REMARKS

Method for Controlled Synchronization to an Astable Clock System, and Reception Unit Corresponding Thereto

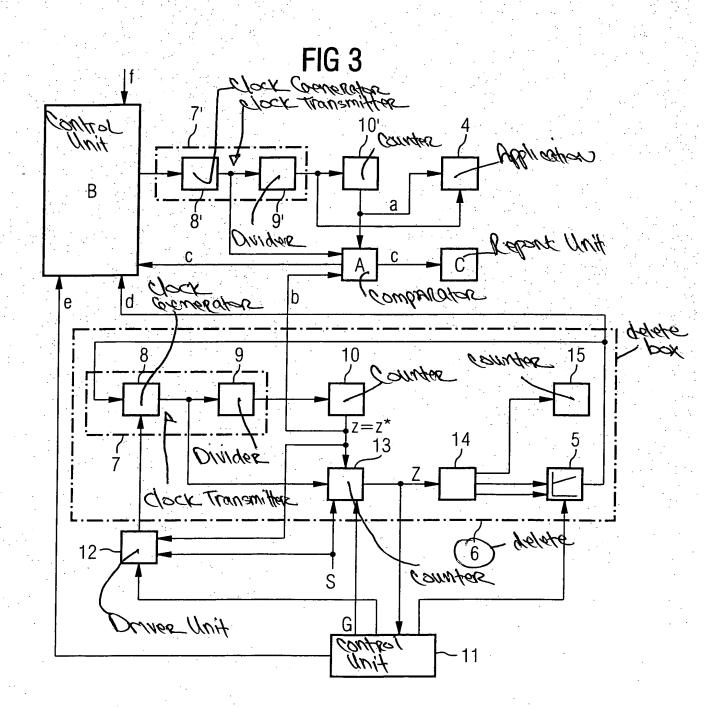
With respect to Fig. 3, an additional amendment has been made by removing the dotted box labeled with numeral "6" to put this figure in conformity with Fig. 2.
